**EVIA Position on the working document on Ecodesign requirements for
Ventilation Units**

11 February 2013

EVIA, the European Ventilation Industry Association, would like to thank you for the further draft working document on Ecodesign requirements for ventilation units dated 17 January 2013.

Figure 1: Typical products and classification according current WD

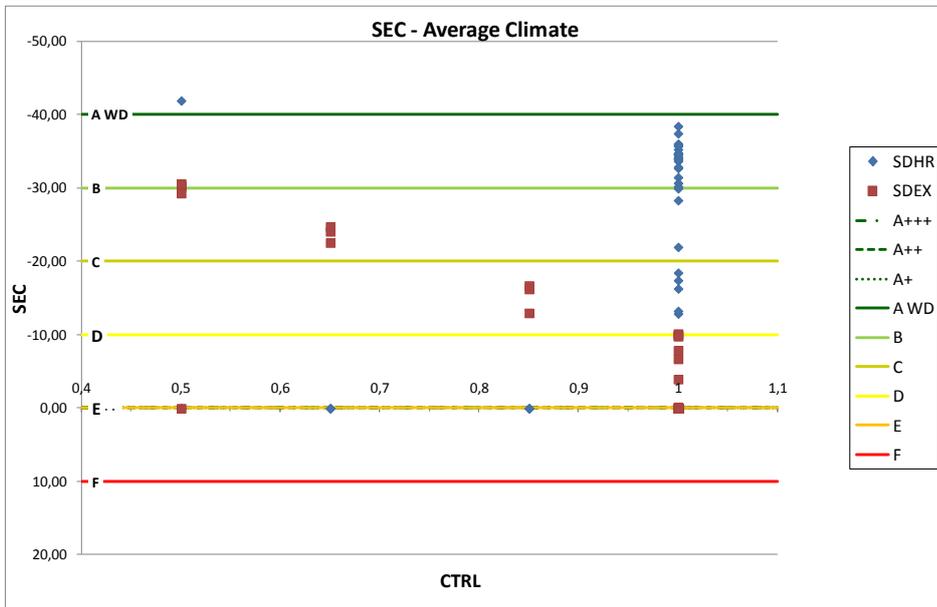
- A very good Exhaust Ventilation System (suitable for refurbishments) shall be able to reach an A classification in average climates (Figure 1, Figure 2, Figure 3).
- In wam climate zones a very good demand controlled exhaust ventilation system is comparable to a good HR-unit (no controls option)(Figure 4).
- In cold climates the exhaust ventilation systems are lower (Figure 5).

Figure 6: Proposal for a modified fan efficiency

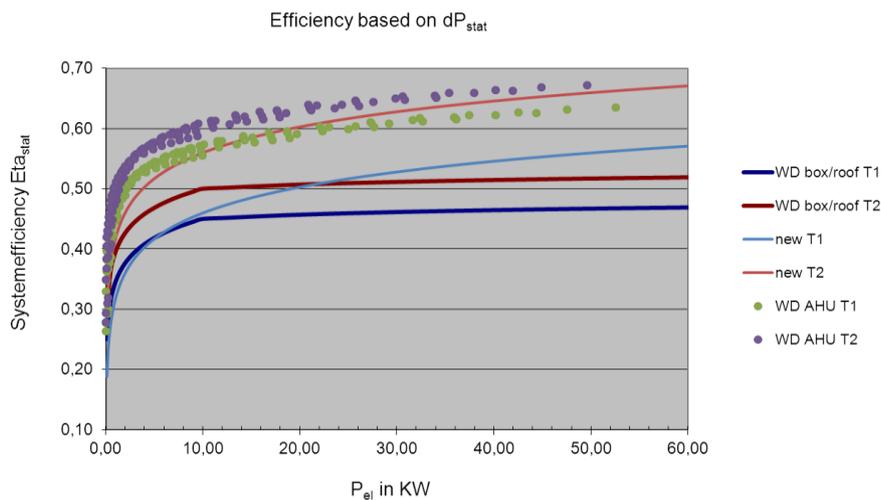
EVIA still stresses the importance to allow different fan designs depending on the application (see comments of December 2012).

As a compromise and considering the current discussion on SFP values EVIA proposes a modified formula for the fan efficiency.

- Solves the inconsistency with EN 13053 pm classes.
- Gives add. 2 years for the industry needed to redevelop a great variety of products and applications
- Comparable efficiency in Tier 1 at higher power, but solves the problems of smaller fans in smaller units to reach the target.
- Higher efficiency in Tier 2

$$\eta_{e,ref} \geq 6,2 \times \text{LN}(\text{Pm}) - 14,3 + X$$

$$\text{T1: } X = 46$$

$$\text{T2: } X = 56$$
